Wisconsin Department of Transportation

Proposal #39: 7220-00-78, WISC 2022255
Durand - Menomonie
Red Cedar River to 490th Street
STH 25
Dunn County

This is Addendum No. 01, which provides for the following:

ADDENDUM NO. 01

Addendum No. 01
ID 7220-00-78
Revised Sheet 68
February 23, 2022

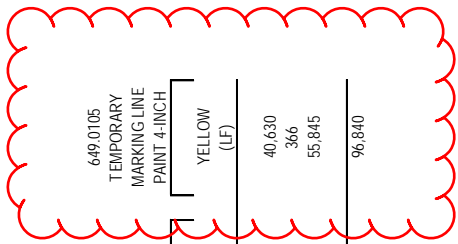
Revised Plan Sheets	
Plan Sheet	Plan Sheet Title (brief description of changes to sheet)
68	Changed Miscellaneous Quantity supplemental description for item 'Barrier System Grading Shaping Finishing' (614.0010) to 'Borrow' instead of 'Excavation Common'.
71	Corrected quantity of 'Temporary Marking Line Paint 4-Inch' (649.0105) from 48,420 LF to 96,840 LF.

BARRIER SYSTEM GRADING SHAPING FINISHING ITEM 614.0010 *

STATION	STATION	LOCATION	BORROW (CY)	SALVAGED TOPSOIL (SY)	FERTILIZER TYPE A (CWT)	SEEDING MIXTURE NO. 20 (LB)	SEEDING TEMPORARY (LB)	SEED WATER (MGAL)
57+92	64+36	LT	365	1,075	1	29	29	24
57+92	64+36	RT	400	1,025	1	28	28	23
TOTALS			765	2,100	1	57	57	47
